**ADDENDUM No. 2**

Date: November 27, 2023

**PROJECT: 23.044.506 GOLD LOT PROJECT**

MBA PROJECT NO. C2306

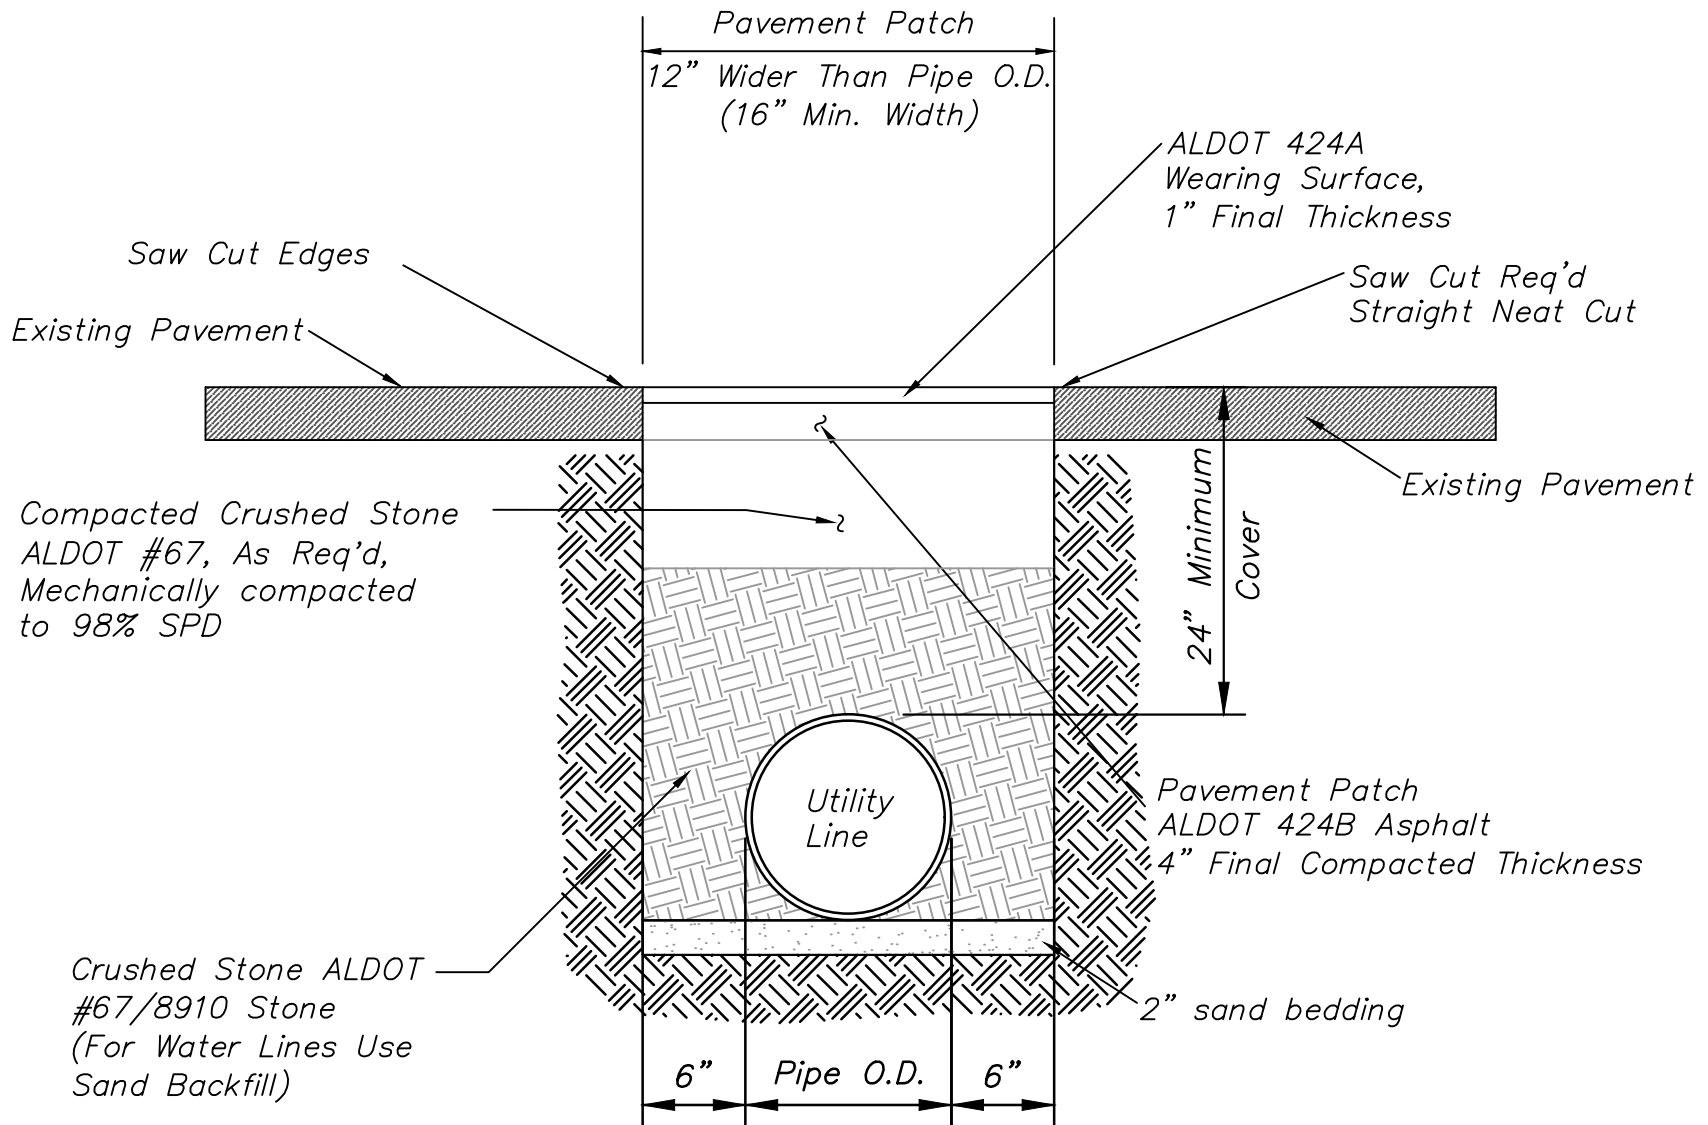
1. Site Plan E2.0 shows note 1 and 2 that do not have a description listed on the drawings. Note 1 in reference to the pull box. Notes 2 is at the riser pole. Replace the existing E2.0 sheet with the attached E2.0 sheet.

## CONDUIT/UTILITY BEDDING AND PAVING PATCH DETAIL

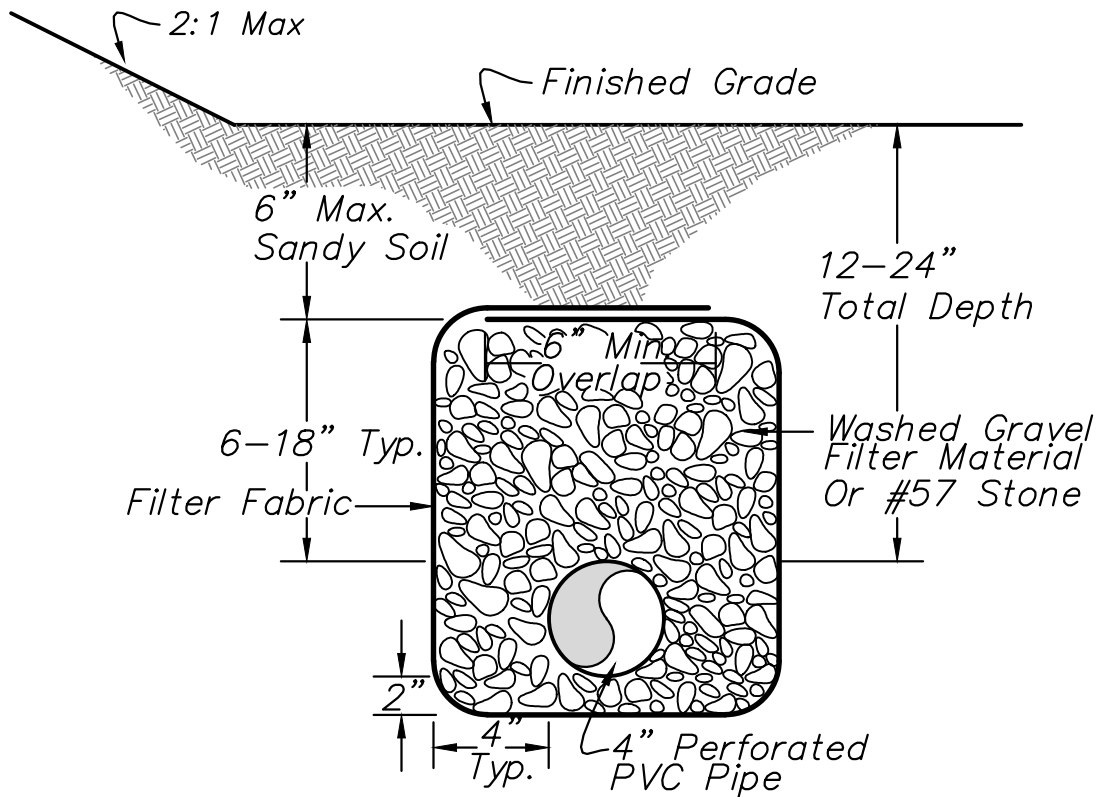
1. Add detail to project drawings: CONDUIT/UTILITY STREET LAYING UNDER PAVING OPEN CUT DETAIL
2. Add detail to project drawings: TOE DRAIN DETAIL

*NOTE: Provide 0.50% Min. Slope*

*NOTE: Downstream Pipe Must Be Solid  
And Have 24" Cover (Min.)*

*NOTE: Connection To Downstream Pipe  
Must Have A C.O. At The Connection*

# TYPICAL GUARDRAIL DETAIL

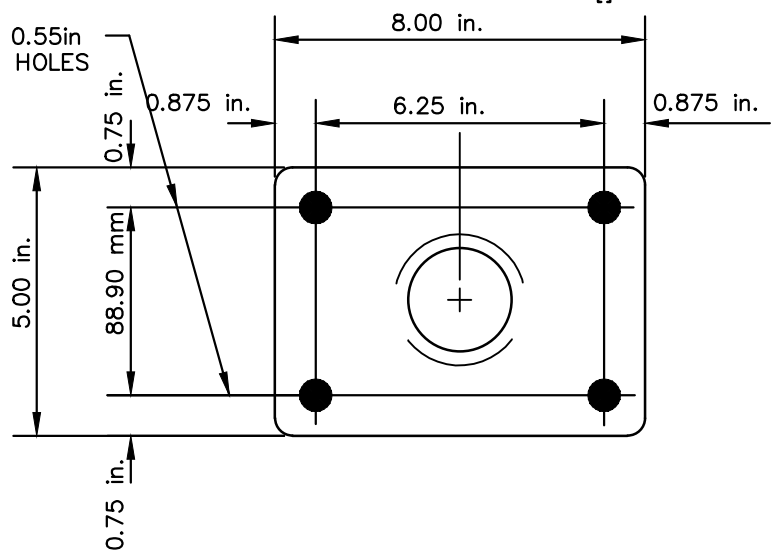
<u>AD 2.0</u>	<u>CIVIL DETAILS</u>
	1. CONDUIT/UTILITY STREET LAYING UNDER PAVING OPEN CUT DETAIL
	2. TOE DRAIN DETAIL
	3. TYPICAL GUARDRAIL DETAIL
<u>AD 2.1</u>	<u>ELECTRICAL PLANS</u>
	1. E2.0 SITE PLAN - ELECTRICAL
<u>AD 2.2</u>	<u>PROJECT MANUAL</u>
	1. BID FORM
	2. ACCOUNTING OF SALES TAX

- GUARDRAIL MATERIAL: 1 1/4" O.D. SCH. 40 STEEL PIPE
- THE CONTRACTOR MAY SELECT TO MOUNT GUARDRAIL TO THE TOP OF THE RETAINING WALL. IN THIS CASE, THE CONTRACTOR SHALL USE A BASE PLATE SIMILAR TO THE ONE SHOWN IN THE DETAIL DESIGNED FOR THE REQUIRED LOADS.

- FOR SLOPING TERRAIN, RAILS SHALL SLOPE PARALLEL WITH GROUND AND BE 38" ABOVE FINISHED GRADE (ON THE HIGH SIDE).
- SHOP DRAWINGS AND SUBMITTALS ARE REQUIRED FOR GUARDRAIL AND HANDRAILS, PAINT, ETC.

- THIS PAINT SPECIFICATION SHALL SUPERCEDE POWER COAT FINISHED CALLED OUT IN HANDRAIL DETAIL
